SERVICE DIRECTIVE BULLETIN NO. T-036
Revision 1

1. SUBJECT: Drive System Flex Packs

2. MODEL: TH-28, 480, and 480B

Figure 1.

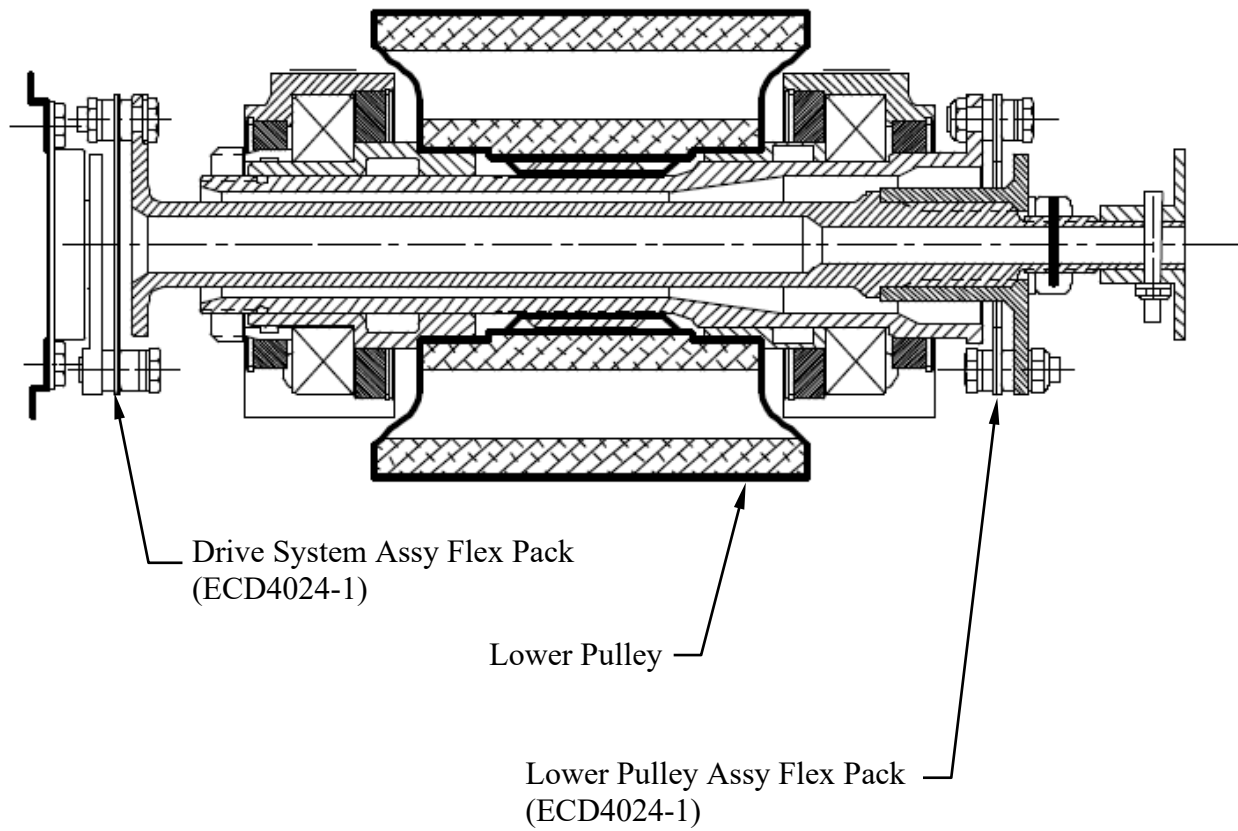
- A. Count the number of elements in each flex pack. There are two flex packs: one on the drive system assembly (forward) and the second is on the lower pulley assembly (aft). Refer to Figure 1. Each flex pack must contain eight (8) elements.

3) Fabricate a gage having a 0.110" wide slotted opening. Align the slot of the gage with the edge of the flex pack. If the flex pack fits in the slot, the pack contains fewer than eight elements. If the flex pack does not fit in the slot, the flex pack contains eight elements

- B. If there are eight elements per flex pack, no further action is required.
- C. If a flex pack contains fewer than eight elements, the flex pack must be removed and replaced in accordance with paragraph 5.2.
- D. Contact Enstrom Product Support with the results of the flex pack inspections.
